EXHIBIT "A"

City of Mansfield Amendments to the 2018 International Residential Code North Central Texas Council of Governments Region

***Figure R602.6.1; delete the figure and insert the following figure:*

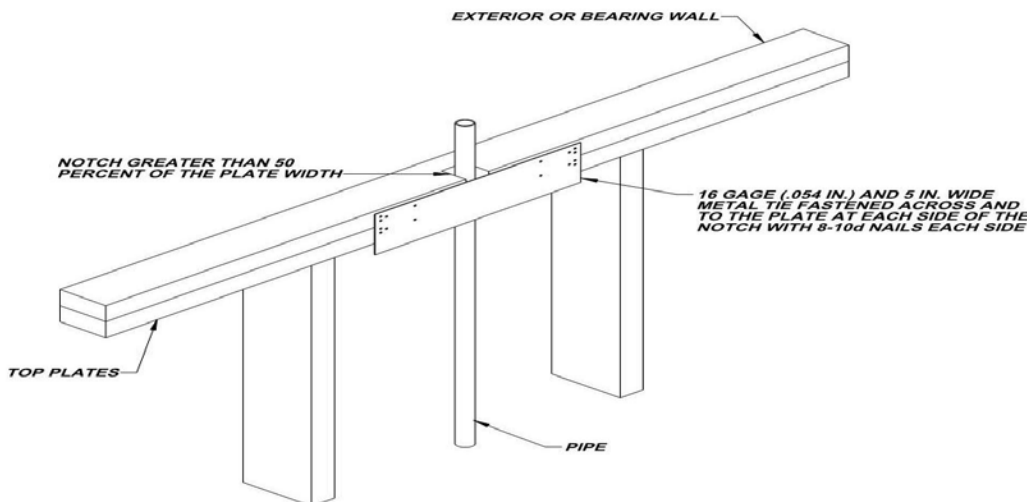
R602.6.1 Drilling and notching of top plate. When piping or ductwork is placed in or partly in an exterior wall or interior load-bearing wall, necessitating cutting, drilling or notching of the top plate by more than 50 percent of its width, a galvanized metal tie not less than 0.054 inch thick (16 Ga) and ~~4 1/2 inches (38 mm)~~ 5 inches (127 mm) wide shall be fastened across and to the plate at each side of the opening with not less than eight 10d (0.148 inch diameter) having a minimum length of 1 1/2 inches (38 mm) at each side or equivalent. Fasteners will be offset to prevent splitting of the top plate material. The metal tie must extend a minimum of 6 inches past the opening. See figure R602.6.1. {remainder unchanged}

(Reason: Amendment to 2015 IRC carried forward to 2018 IRC. Also, provides additional assurance of maintaining the integrity of the framing by spreading the nailing pattern.)
